Access Compliance Report

Public Rights-of-Way

(Curb Ramps)

Intersection ID: 10023686	Main Street: COCA-COLA PLAZA	Cross Street: N/A	Location: SE
ADA ID: 7E6C7FB00798	Ramp Type: Perp	Initial Pass/Fail: Fail	Overall Compliance: No
Severity Score: 26.25			
Codes/Mitigation Info/Possible Solution		Field Measurements/Component Compliance

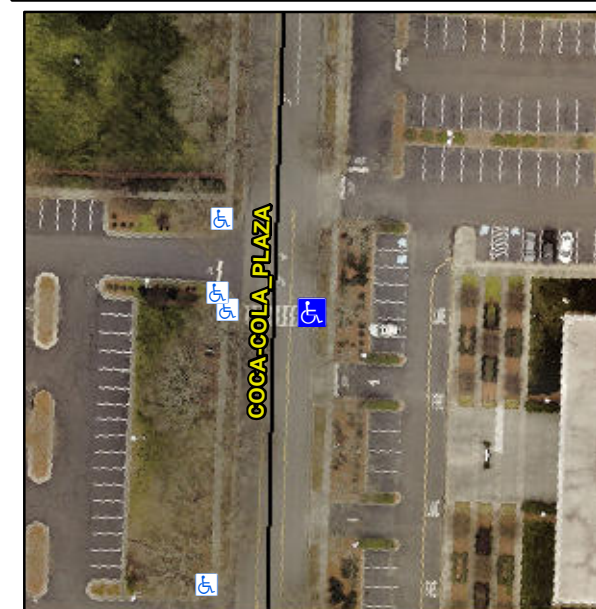
R304.2.2, R304.5.3

Compliance	Description	Data	Compliance	Description	Data
N/A	Ramp Length (in)	77.0	No	Ramp Slope (%)	12.6
Yes	Ramp Width (in)	48.0	No	Ramp XSlope (%)	2.1
N/A	Flare Type LT	N/A	N/A	Flare Type RT	N/A
N/A	Flare Slope LT (%)	N/A	N/A	Flare Slope RT (%)	N/A
N/A	Flare Traversable LT?	N/A	N/A	Flare Traversable RT?	N/A
N/A	Landing Length (in)	N/A	N/A	DWS Provided?	N/A
N/A	Landing Width (in)	N/A	N/A	DWS Contrast?	N/A
N/A	Landing Slope (%)	N/A	N/A	DWS Length (in)	N/A
N/A	Landing X Slope (%)	N/A	N/A	DWS Full Width?	N/A
N/A	Landing Curb? (Y/N)	N/A	N/A	DWS Offset (in)	N/A
N/A	Shared Landing?	N/A			
N/A	Gutter Ponding?	N/A	N/A	Gutter Slope (%)	N/A
N/A	Gutter Lip Ht (in)	N/A	N/A	Gutter X Slope (%)	N/A
N/A	Painted X Walk1?	Yes	N/A	Painted X Walk2?	N/A
	X Walk 1 Direction	To W		X Walk 2 Direction	N/A
N/A	X Walk 1 Width (in)	108.0	N/A	X Walk 2 Width (in)	N/A
	X Walk 1 Slope (%)	3.3		X Walk 2 Slope (%)	N/A
	X Walk 1 X Slope (%)	0.7		X Walk 2 X Slope (%)	N/A

Remove & Replace Entire Ramp.
